Defense Nuclear Facilities Safety Board (Board) Recommendation 96-1 expressed concern about benzene generation and release at the In-Tank Precipitation (ITP) Facility at the Savannah River Site. Members of the Board staff recently completed a technical evaluation of benzene generation, retention, and release at ITP. Their report, *Savannah River Site In-Tank Precipitation Facility Benzene Generation: Safety Implications*, evaluates the safety implications of these phenomena and assesses what should be understood about the processes before full-scale ITP operations proceed.

**SAVANNAH RIVER SITE
IN-TANK PRECIPITATION FACILITY
BENZENE GENERATION:
SAFETY IMPLICATIONS**

Technical Report

February 3, 1997

Figure 4. Calculated Time to CLFL

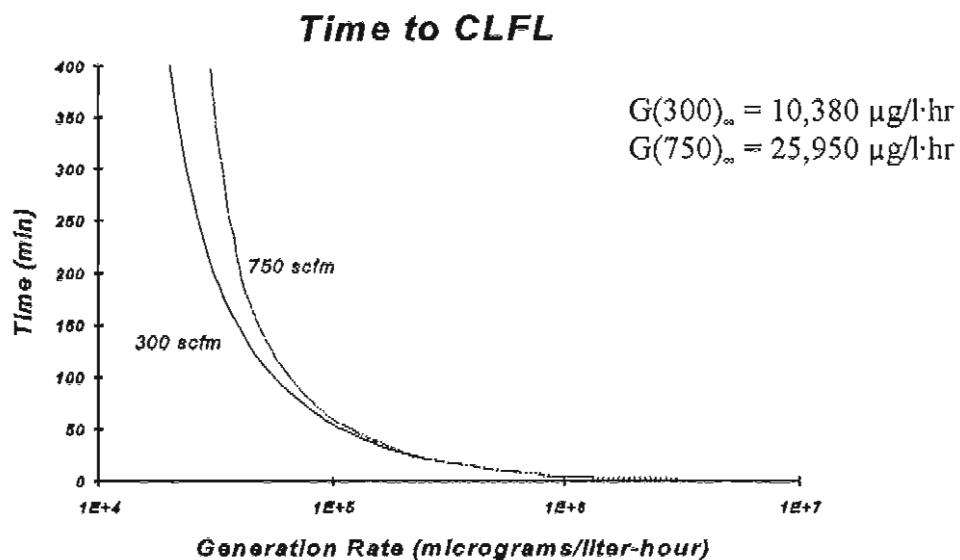
concentration. Figure 4 provides a graph of the time required to reach the CLFL for various benzene generation rates (with no retention), given a slurry volume of 300,000 gallons and purge flow rates of 300 scfm (design minimum) and 750 scfm (typical system flow rate). From these calculations, it is clear that the retention of the benzene in the slurry was fortuitous.

Board staff believe that the benzene retention property of the solids was the only barrier to a flammable concentration of benzene during the process excursion. A more limiting case might involve another method for the release of benzene other than pump operation. For example, the benzene could be released with the use of a surfactant if the benzene were held by surface tension with solids in the liquids.
